CITY OF PORTLAND

BUILDING PERMIT

Job ID: 2011-07-1759-ALTR

has permission to build a 16 by 31.5 foot addition (Single Family Residence).

Summit Park Ave (road)

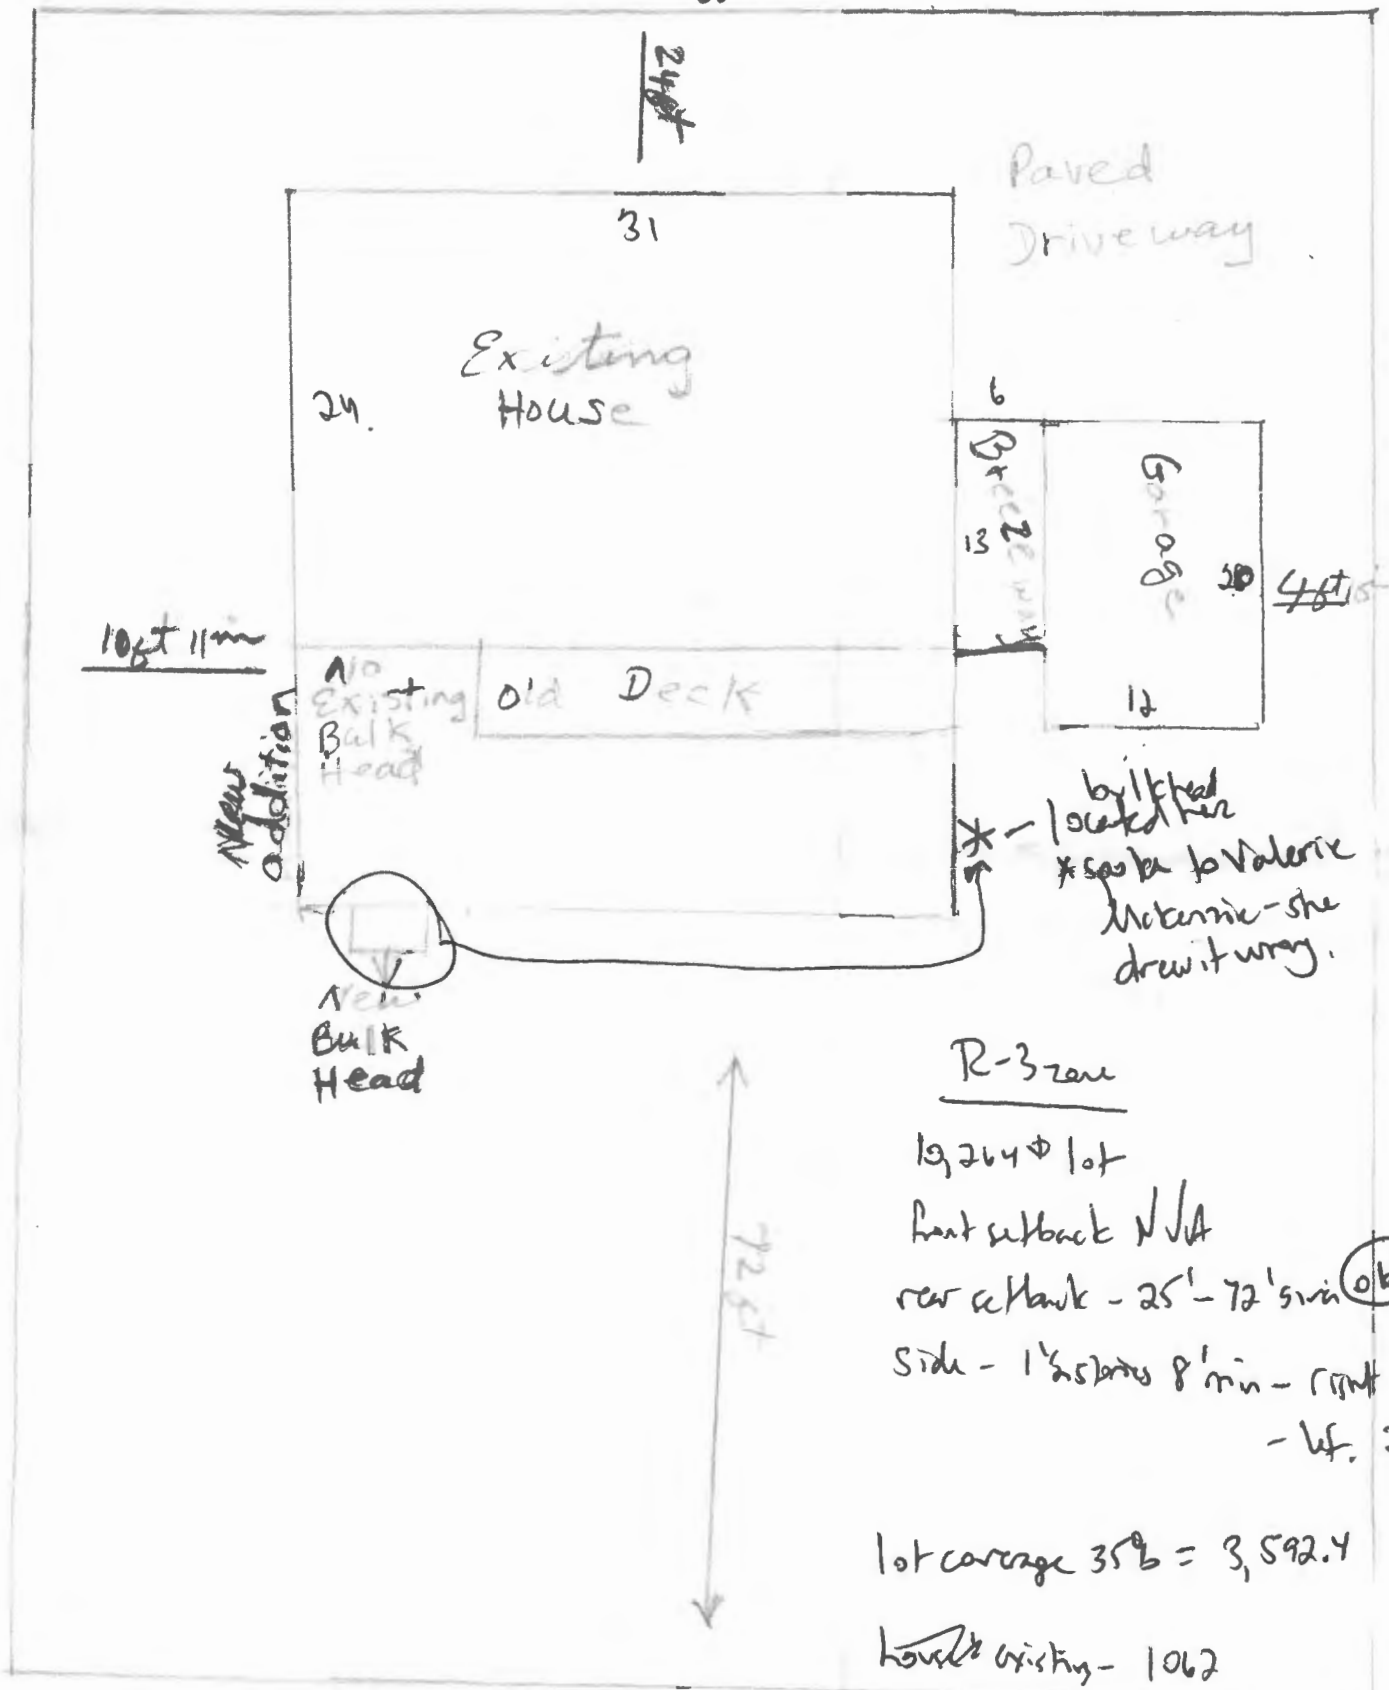
rear setback - 25' - 72' 5" min (ok)

side - 1' 2" setback 8' min - front 10' 10"

lot coverage 35% = 3,592.4

1572 + 8126 (ok)
